107E-5558-JWH
6 May 2004

RE: Comments Concerning the McDonnell Douglas RCRA Facility Investigation (RFI) Report, Hazelwood, Missouri; Permit # MOD000818963

Encl: Revised RCRA Facility Investigation Report for McDonnell Douglas, Hazelwood, Missouri

Figure 2-11
Generalized Hydrogeological Column and Comparison to SLAPS Hydrostratigraphic Zones (HZ), Boeing Tract 1 RFI, Hazelwood, Missouri

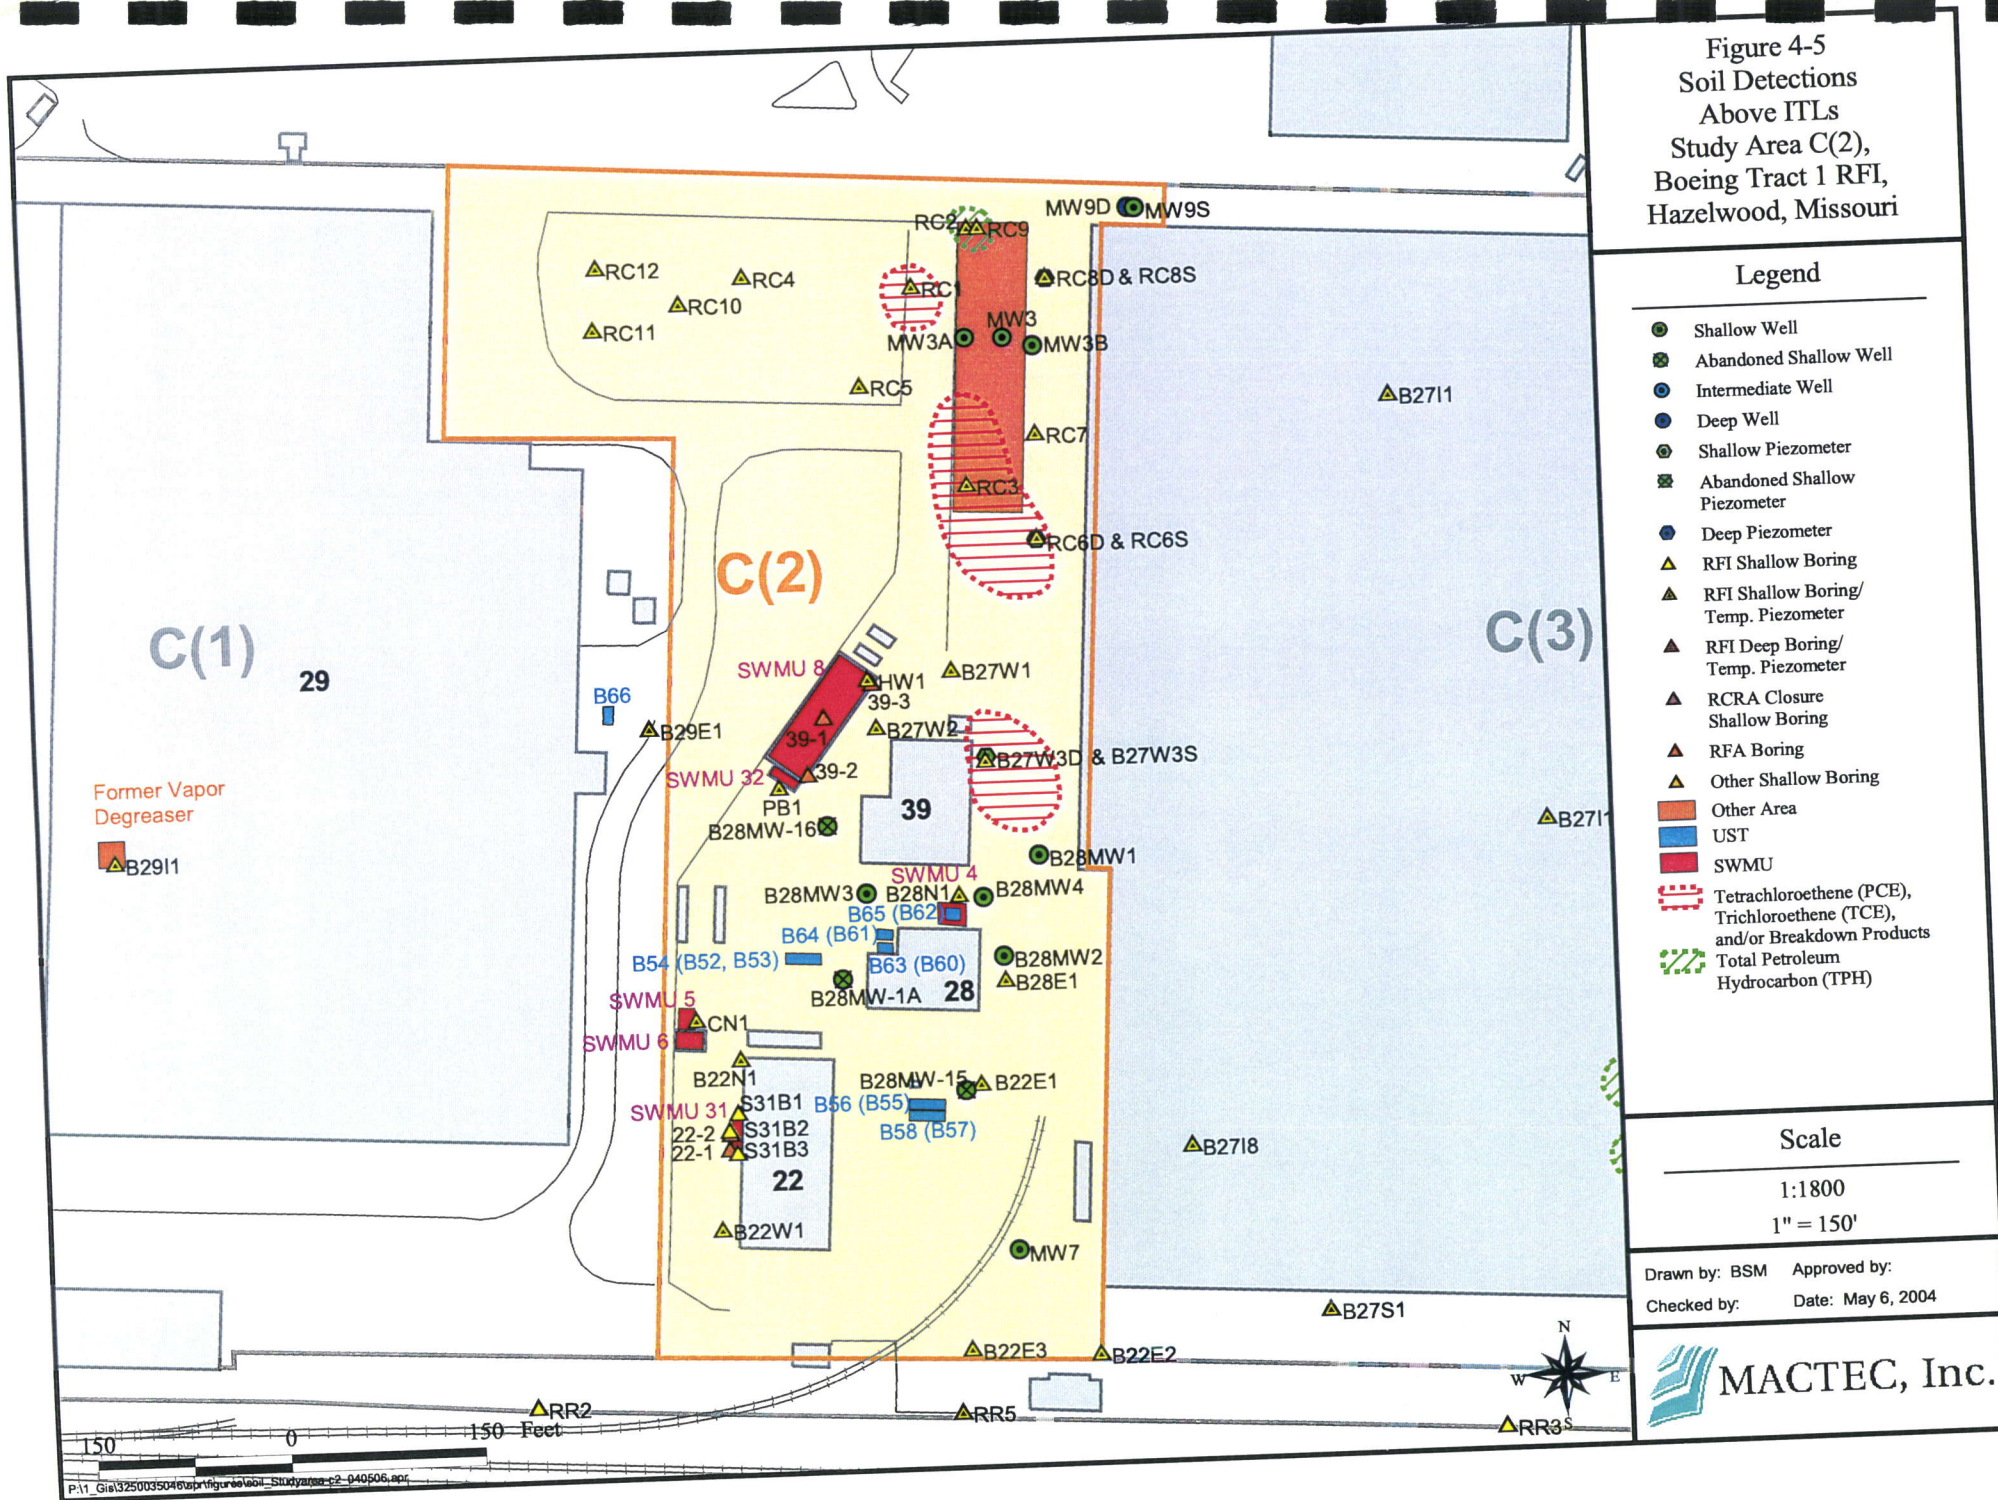
Figure 2-11 General Hydrogeologic Column.

- The silt "horizon" has been made the top of the confining unit and Figure 2-11 (Figure 2-12 in the revised draft) revised to show that change.
- Agree that there is little flow of water in or through the confining unit, added text to Section 2.7.3 and 2.7.3.2.

- Figure 2-11 (Figure 2-12 in revised RFI) has been revised to show silt as the top of the deep/confining unit.
